**Florida  
Power**  
CORPORATION

Subject: Crystal River Plant Unit #3  
Docket 50-302

Re: Nuclear Services and Decay Heat  
Sea Water System Analysis

EVALUATION REPORT1-23-74  
Dr. C. ChenNUCLEAR SERVICES AND DECAY HEATSEA WATER SYSTEM

Exhibit 1

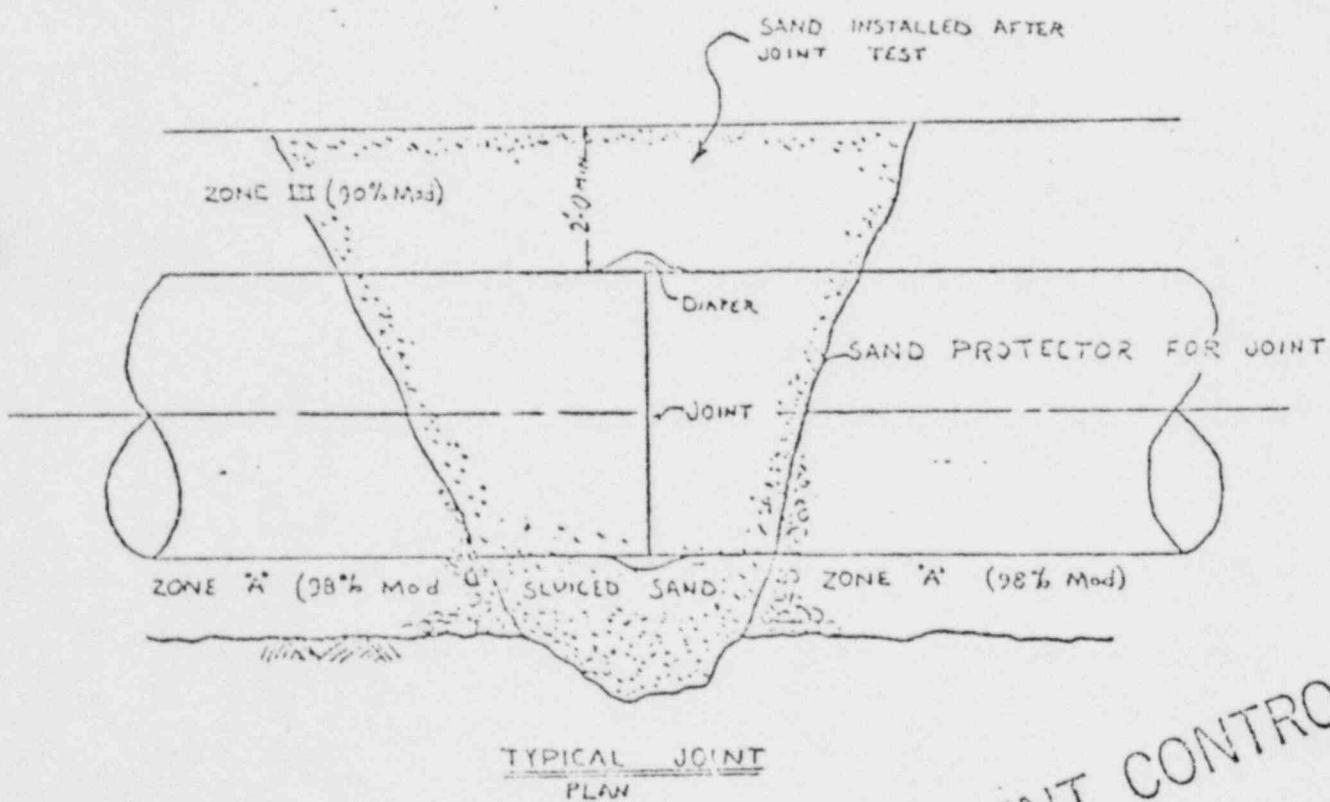
- 5.2 Excavation, placing of pipe, and fill shall be in accordance with Exhibits 1 and 2.
- 5.3 The trench bottom shall be excavated as close to grade as possible (at least 8" below the bottom of the pipe).

- 5.8 Approximately 5 inches of Zone "A" material shall be compacted to 98% maximum density (see section 5.6) and subsequently cut to leave two trapezoidal trenches four feet wide in which the pipe will rest (see Exhibit 1).

DRAWING NUMBER  
D-4-300

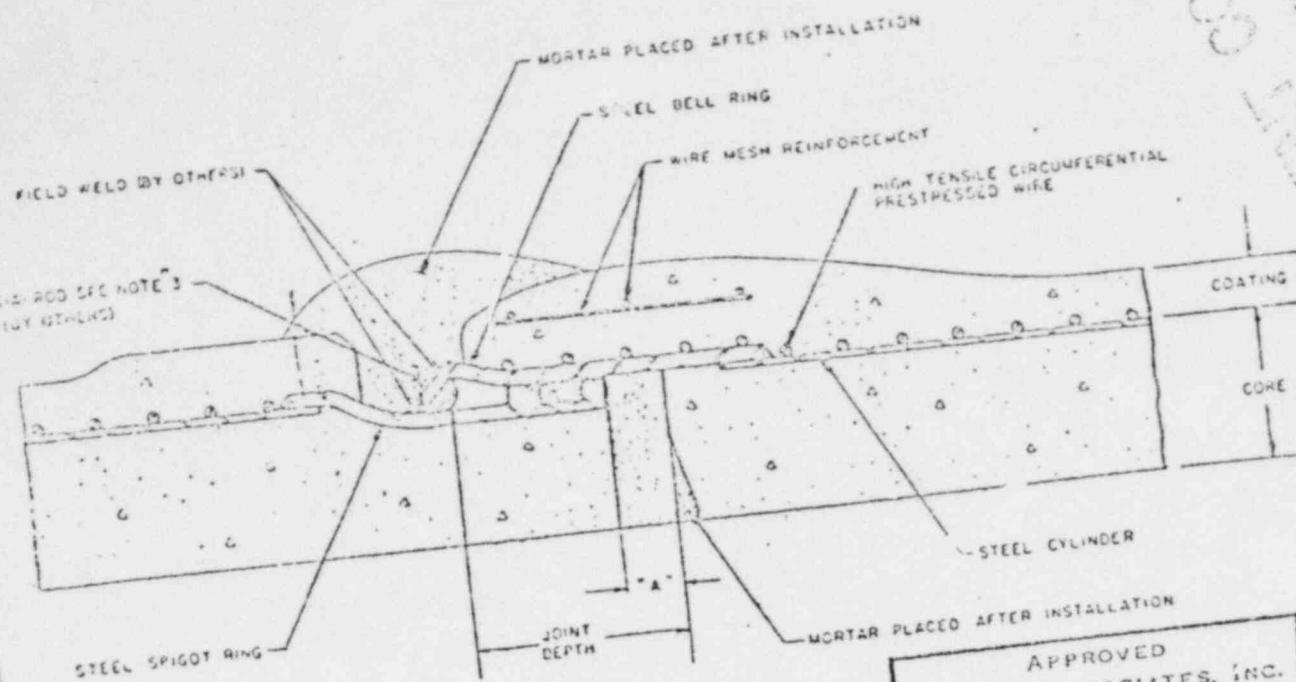
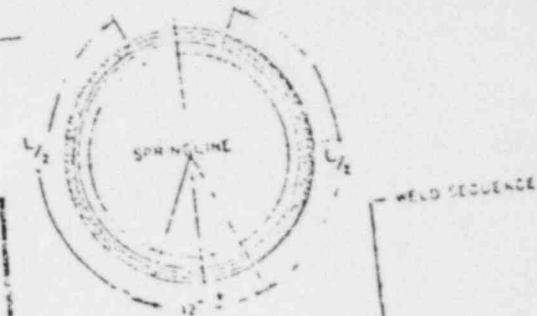
Void Field Change #6 to Procedure JAJ-W52, and write Field Change #7 to have the welding of the wedge ring to bell ring meet the vendors approved welding requirements.

Weld the wedge ring to the bell ring, to the requirements of Interpar drawing D-4-390, using E-6010 Electrodes.

Reason For Change: Delete Para 6.6 and last four sentences of para. 6.7

Add: Pipe joint shall be sealed at a convenient time  
following the Manufacturers Drawing.

Ref. Drawings : D-3-682  
SS-CO-69-15-7 & D-3-691  
D-4-390 (See Field Change #7)
